UNITED STATES PATENT AND TRADEMARK OFFICE

APPLICATION NO.	FILING DATE	FIRST NAMED INVENTOR	ATTORNEY DOCKET NO.	CONFIRMATION NO.
09/681,545	04/26/2001	Dennis P. Bobay	03-DV-7090	9760

Office Action Summary

DETAILED ACTION

as shown in Figure 25.

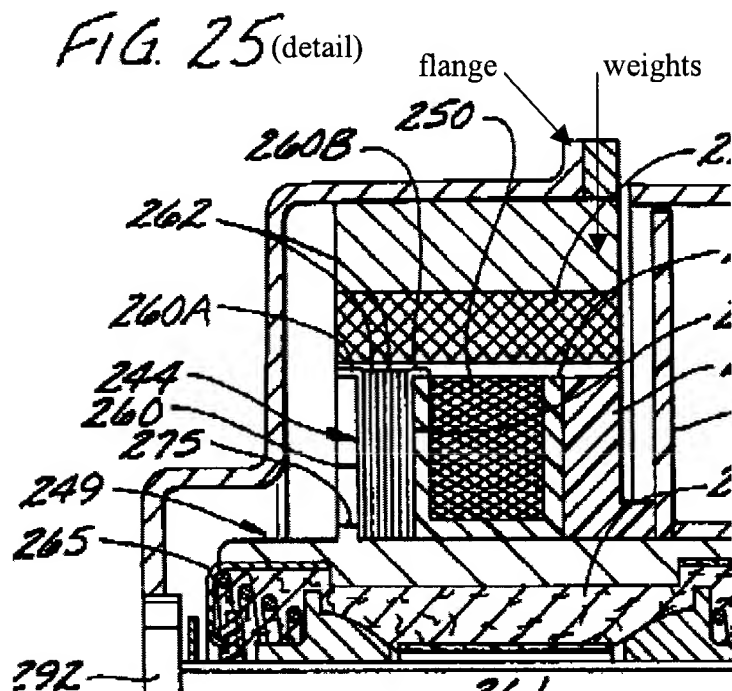
10. With regards to claim 6, 7, 9 and 10 Hollenbeck et al. discloses a rotor cup assembly, wherein:

said annular flange is configured to have an edge, said edge outwardly flared from said sidewall by an angle Φ ;

said annular flange configured to receive a plurality of weights (added by the examiner) to facilitate a desired level of rotor balance;

said annular flange second diameter greater than said housing sidewall first diameter;

said annular flange provides a smooth surface for pressing an item into said rotor cup;
